## ADDENDUM #2

To: Known Qualified Firms  
From: Porter Co. Dept. of Development & Storm Water Management  
Date: June 22, 2021  
Subject: Saddlebrook Subdivision – Storm Water Management System Improvements  
Construction Services

### **Clarifications & Modifications**

PROJECT:	SADDLEBROOK SUBD. -SWM SYSTEM IMPROVEMENTS
LOCATION:	SADDLEBROOK SUBDIVISION
SHEET TITLE:	SHEET 2-OVERALL PLAN

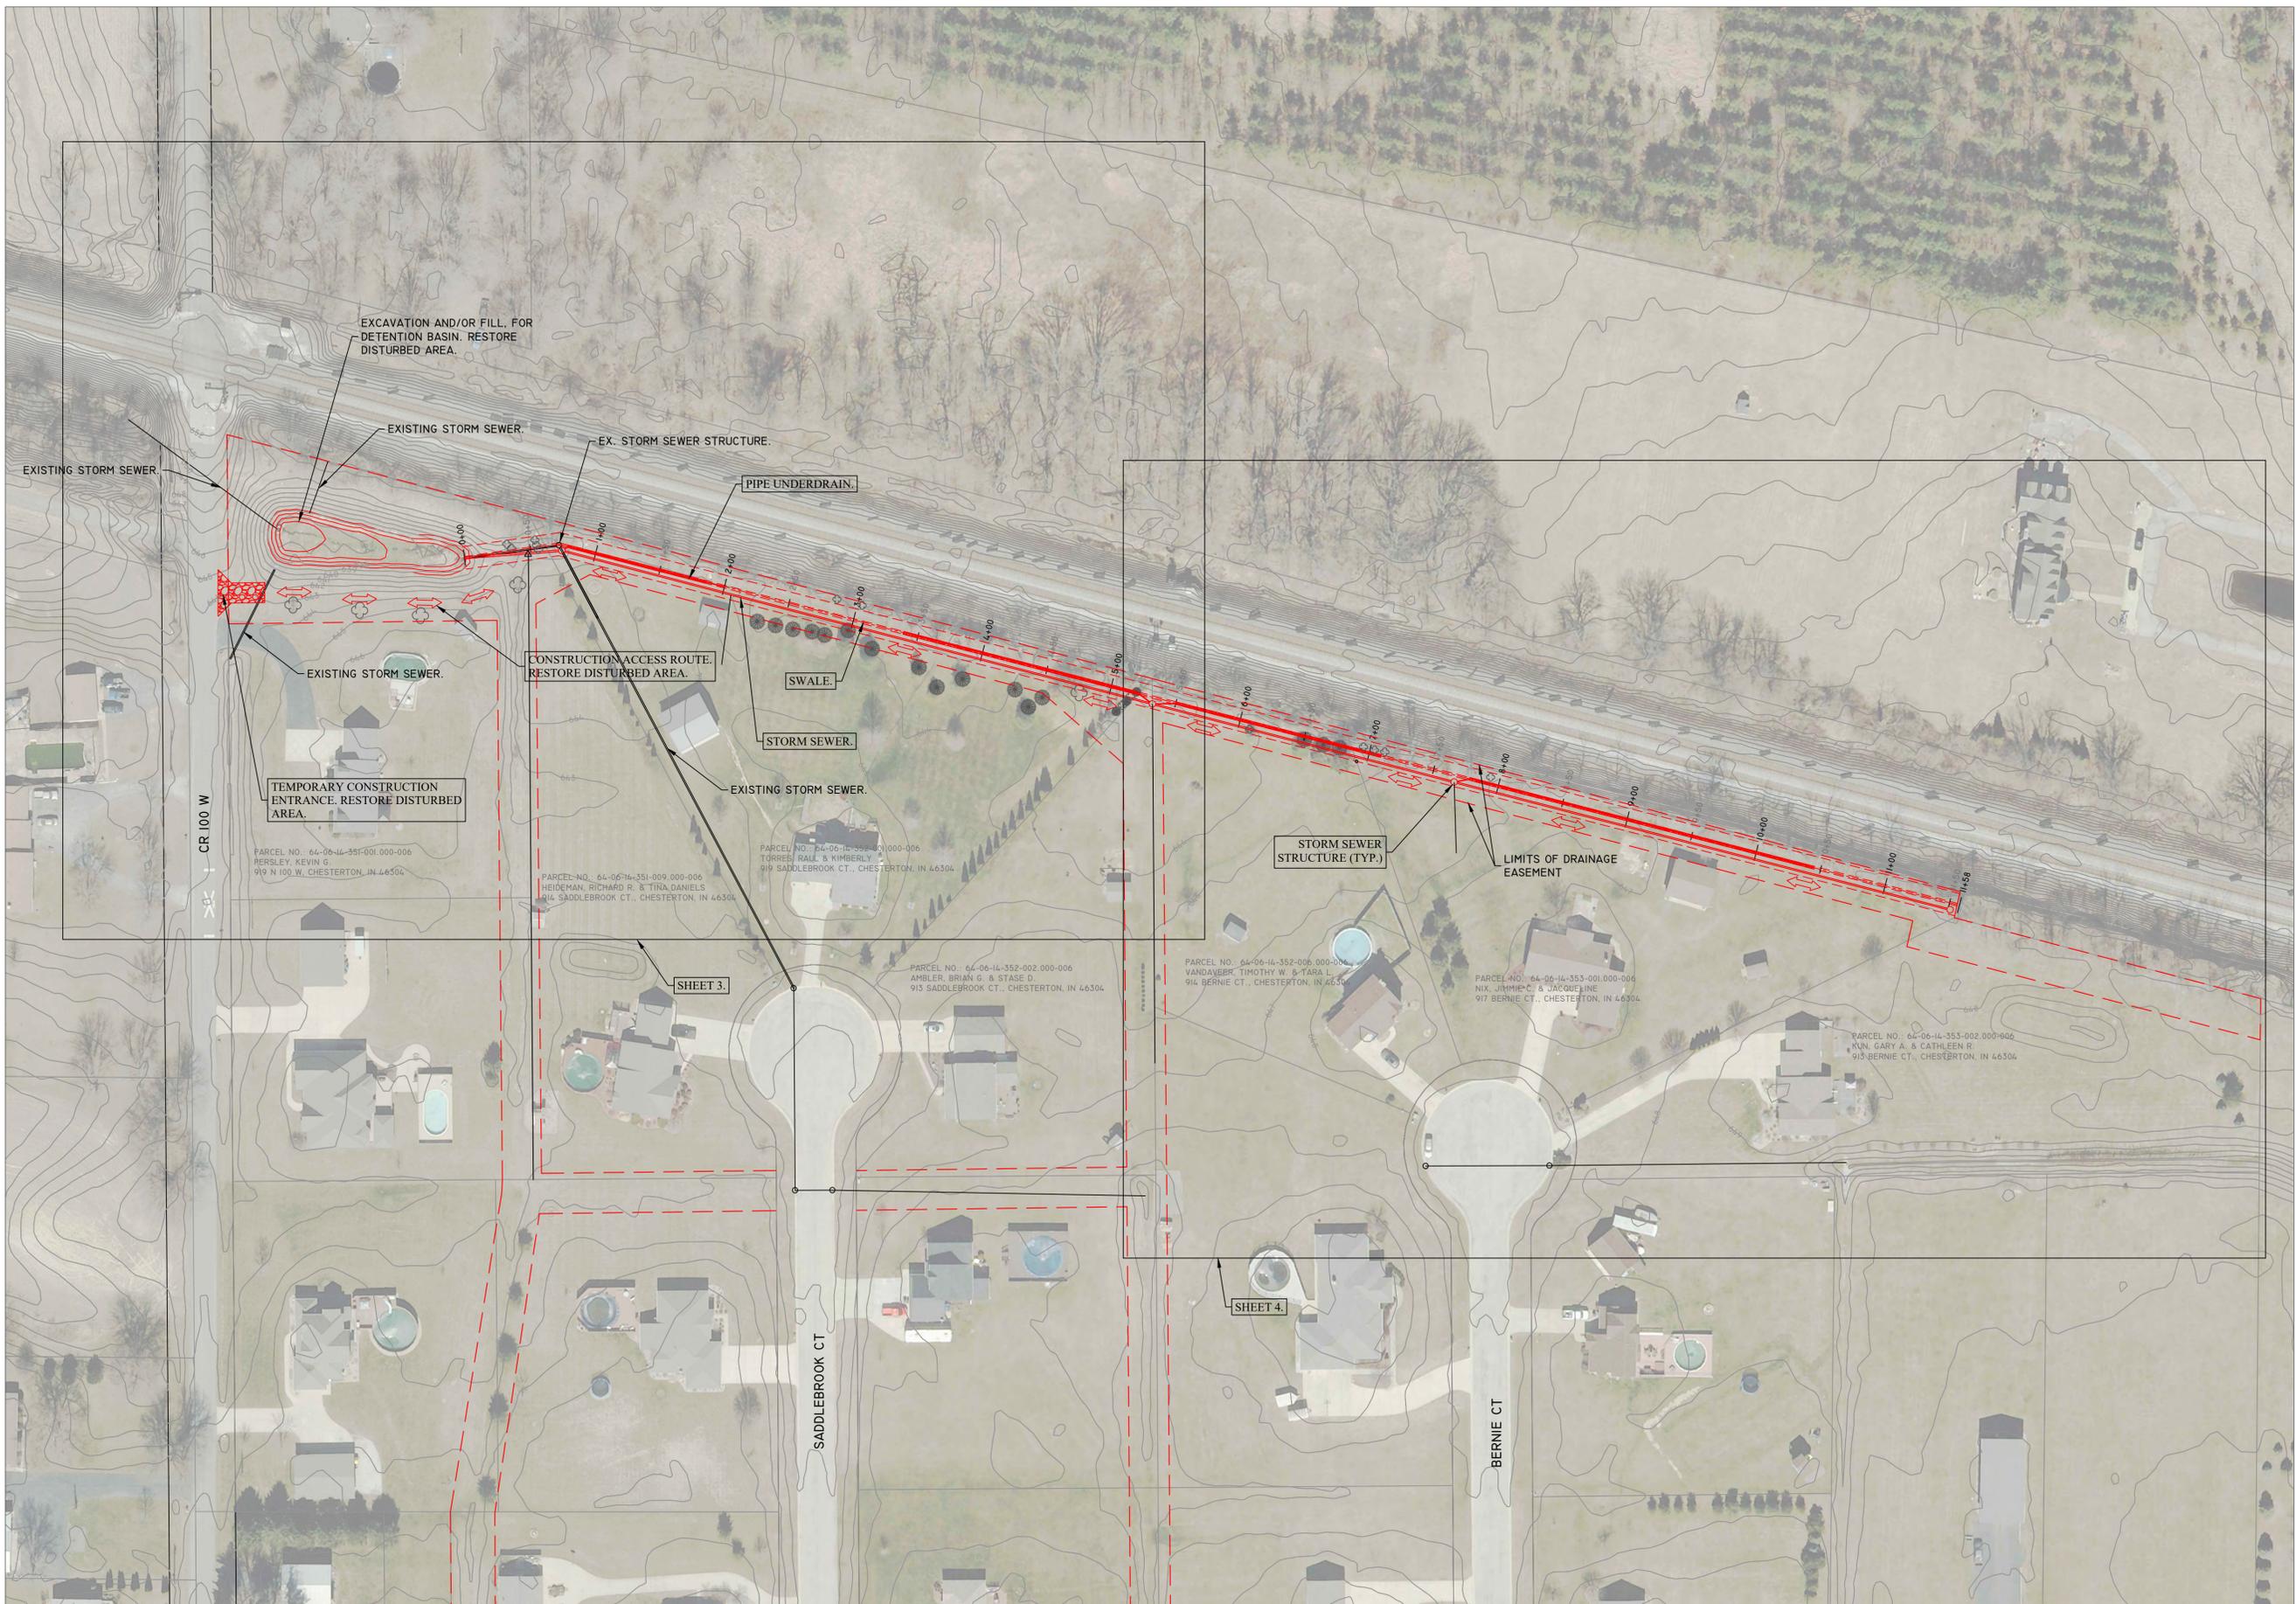
#### 2. Contour Line Labels

**To clarify**, the contour lines, which were generated based on LiDAR Data, have been labeled to provide a reference for the adjacent grade.

Q9: The contour lines do not align with the existing spot elevations. Are the contour lines in 1 FT increments and can you please clarify the elevations of the existing contour lines?

A9: The points shown are the survey data that was collected. The contours shown are based on LiDAR data, which is an approximation of the site elevations, therefore, the contours will not align with the spot elevations. The elevations of the contours have been added to the plan and will be included with Addendum 2. The contours are in 1 FT increments. The earthwork calculations were done in CAD using a surface created from the survey data compared to the proposed contours.

PROJECT:	SADDLEBROOK SUBD. - SWM SYSTEM IMPROVEMENTS
LOCATION:	SADDLEBROOK SUBDIVISION
SHEET TITLE:	SHEET 3-PLAN STA. 0+00 TO STA. 5+50

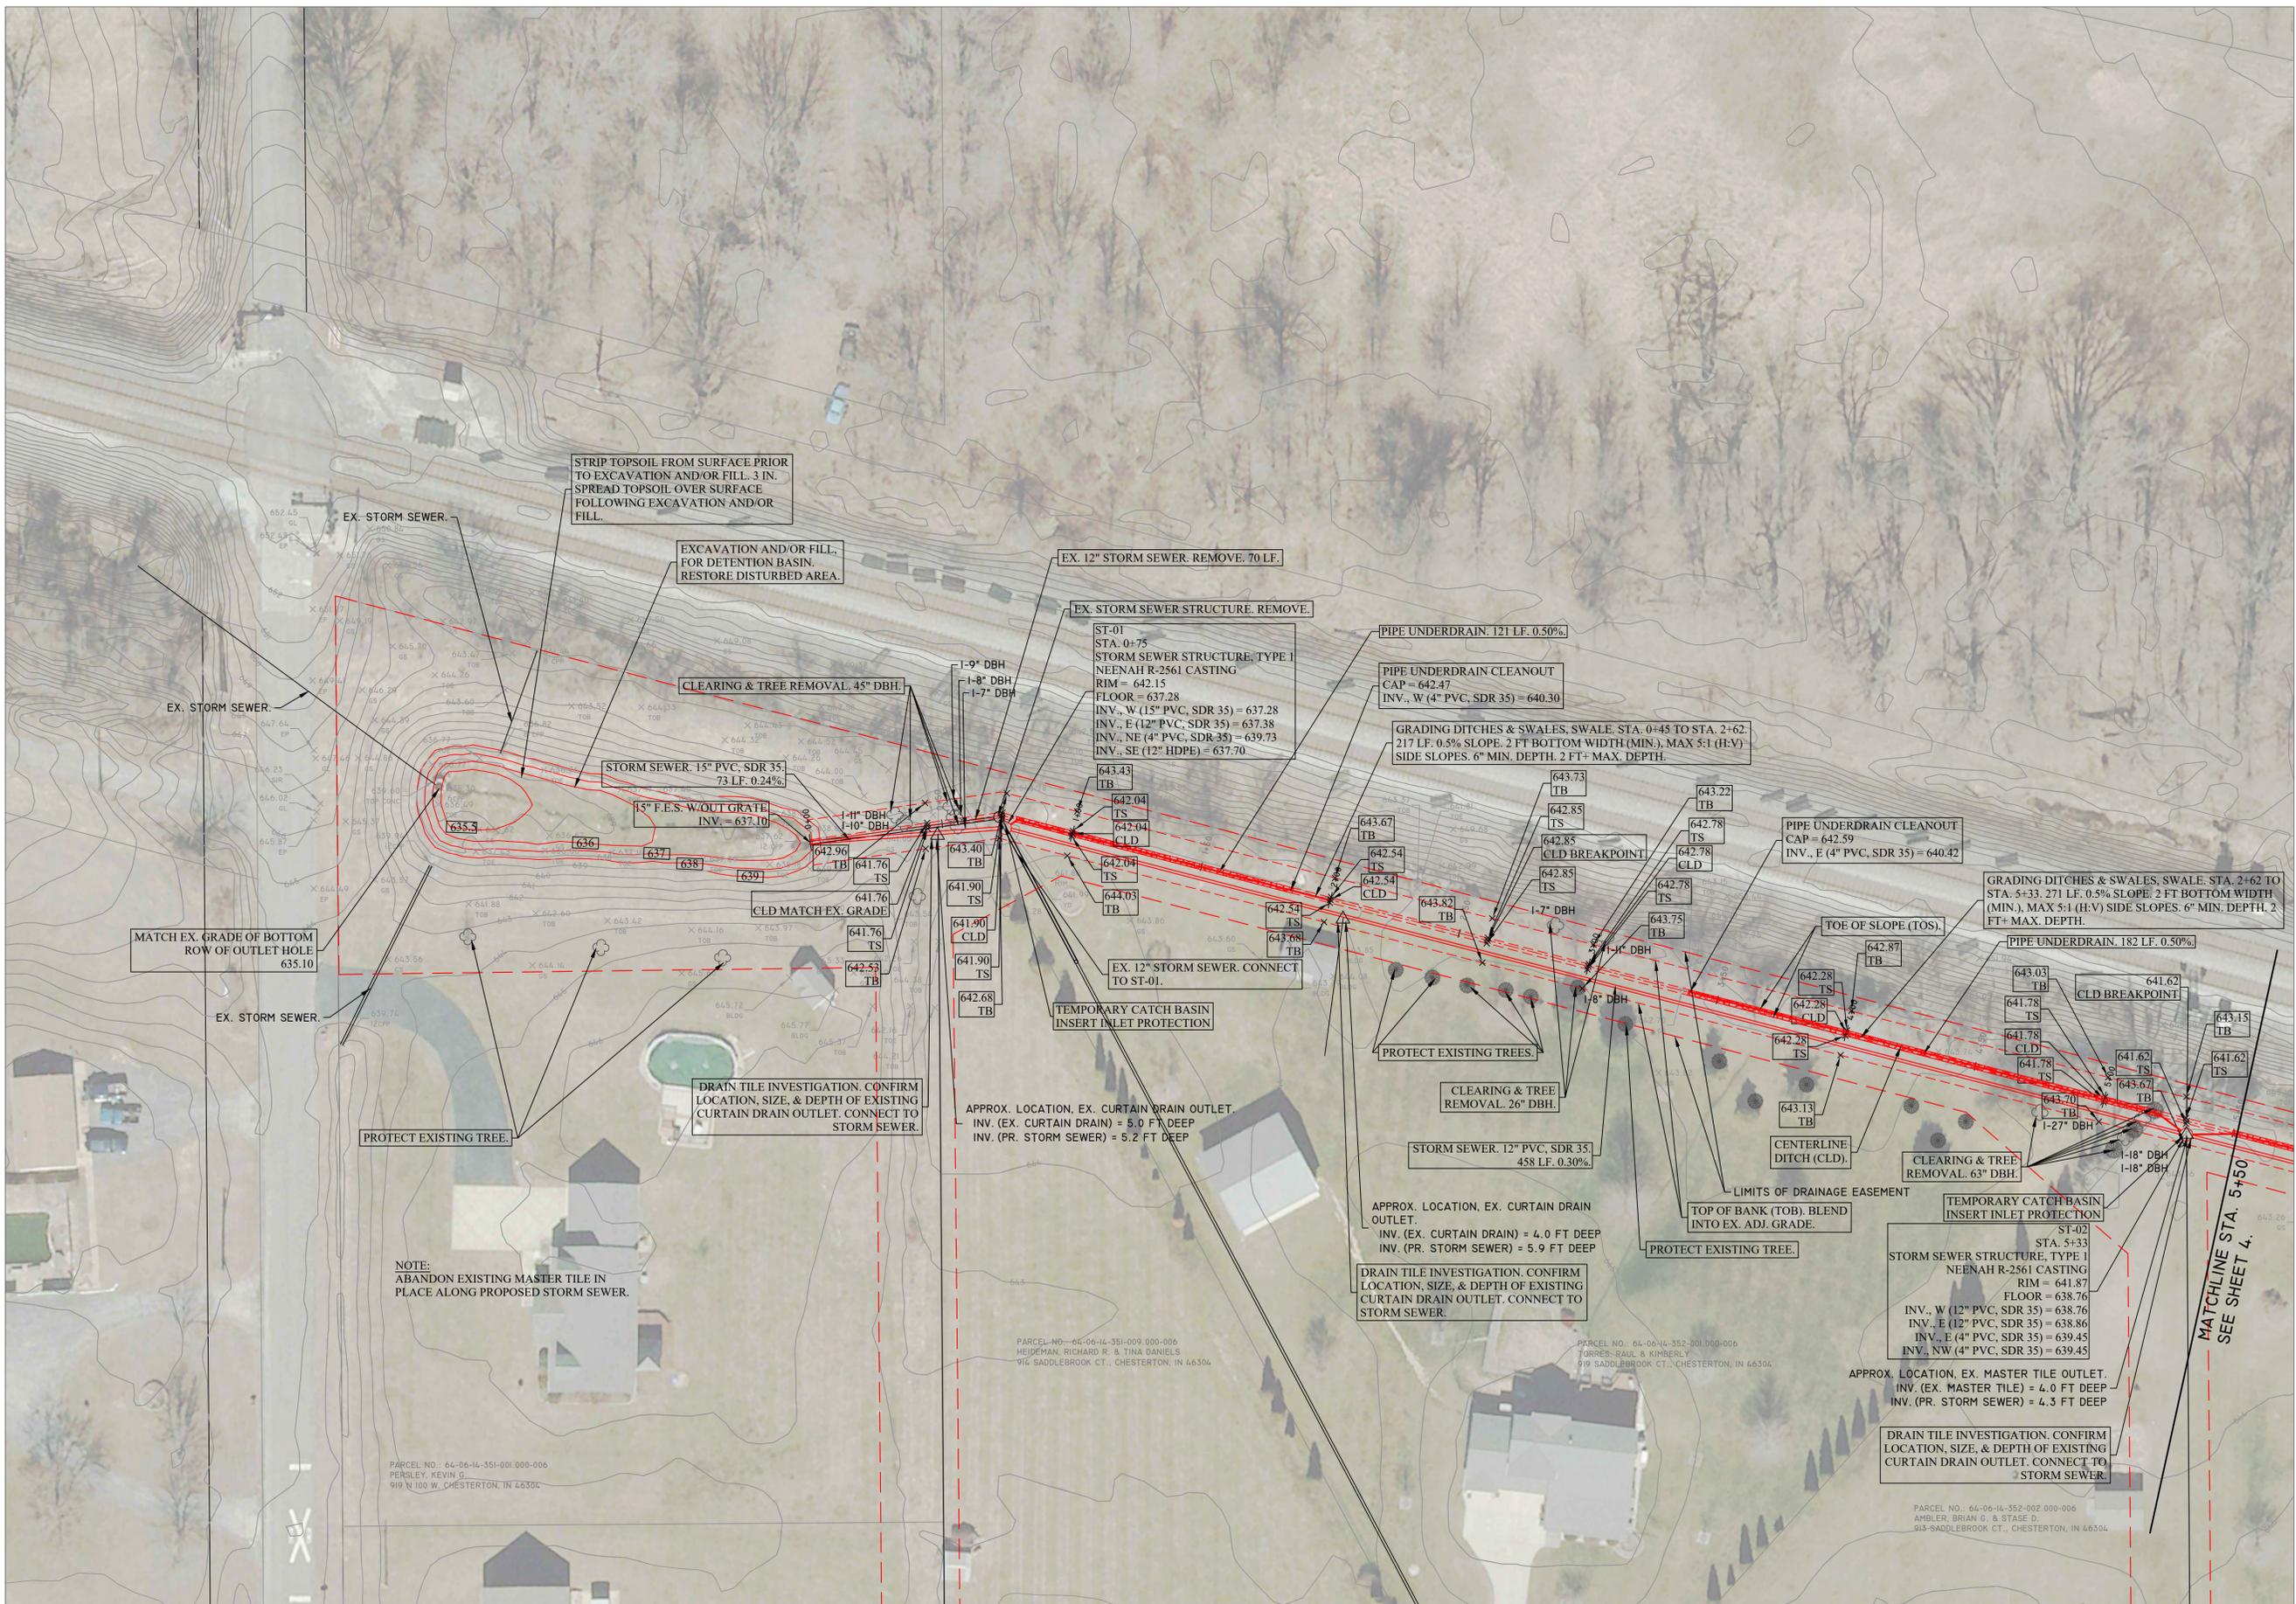
#### 3. Excavation and/or Fill for Detention Basin

**The construction plans have been revised** to provide additional guidance and information related to the proposed grading of the detention basin.
